TECHNICAL SERVICE BULLETIN

05MY-15MY CONVENTIONAL J08 ENGINE CYLINDER HEAD GASKET

Group:	11-Engine
Bulletin No.:	SB-15-026
Issue Date:	06-02-2015

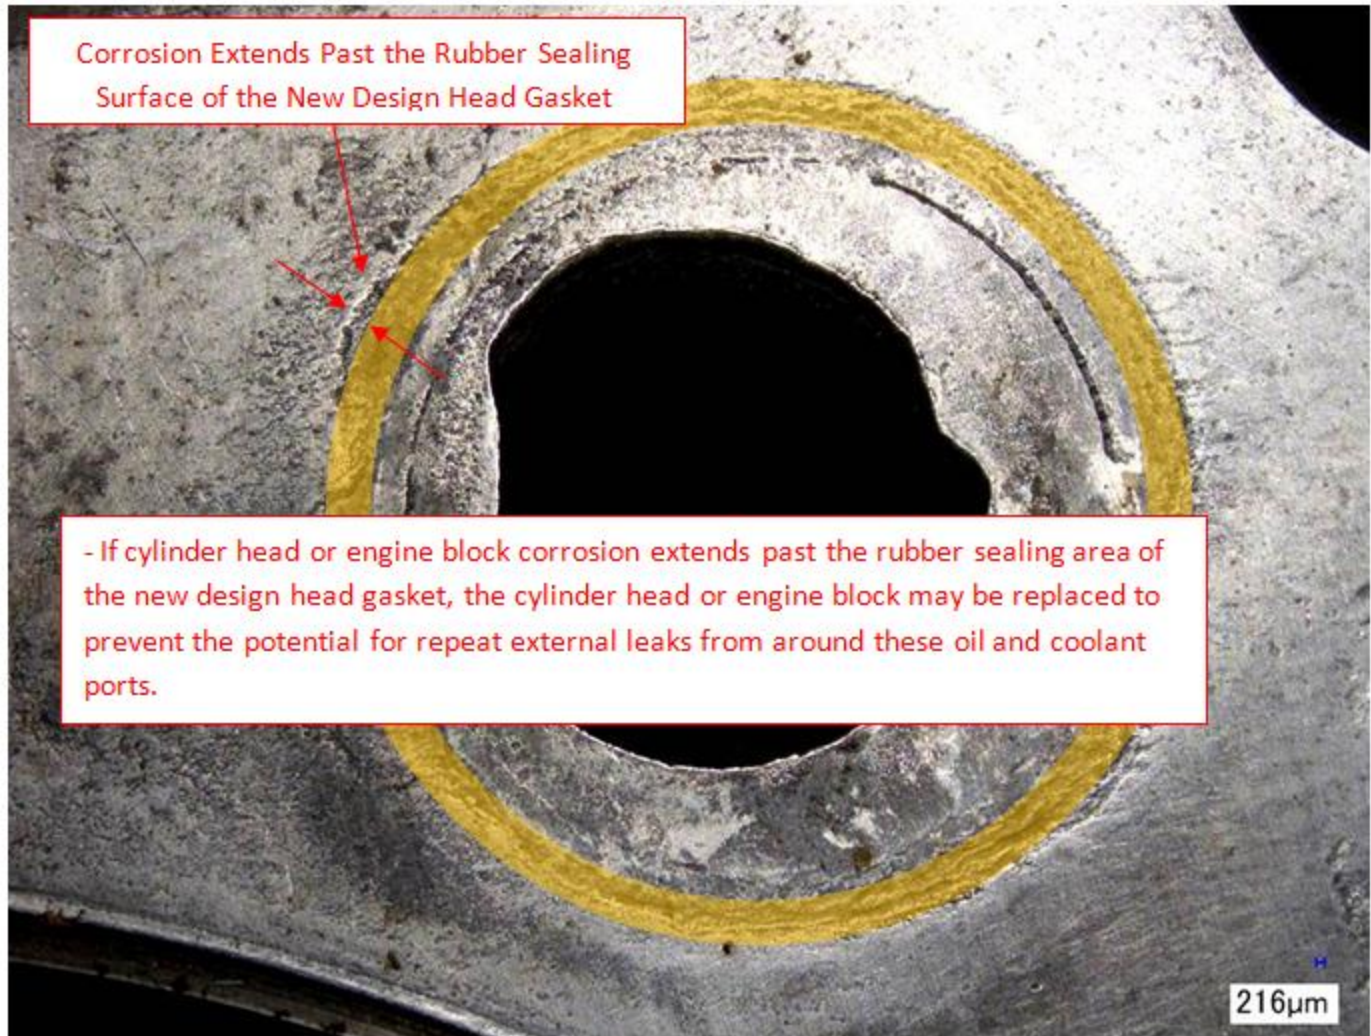
A subject vehicle may exhibit an engine oil leak or engine coolant leaking externally from the engine head gasket sealing area on the exhaust manifold side of the engine. An improved head gasket has been made available as a service part and should be used if replacement of the head gasket is necessary. Improvement of the head gasket includes the addition of rubber seals around the engine oil and engine coolant port holes.

- In rare cases, corrosion or fretting may occur around the engine oil return ports and engine coolant ports. There are 24 corresponding ports which are located on the cylinder head and engine block. The locations correspond to the rubber seals which were added to the new design head gasket. Refer to the corresponding locations using the new cylinder head gasket as a template.

- Should it become necessary to perform any operation where the cylinder head gasket will need to be replaced this new design head gasket should be used.
- Refer to section "EN02-001 Engine Mechanical (J08E)" for disassembly, inspection and assembly procedures.
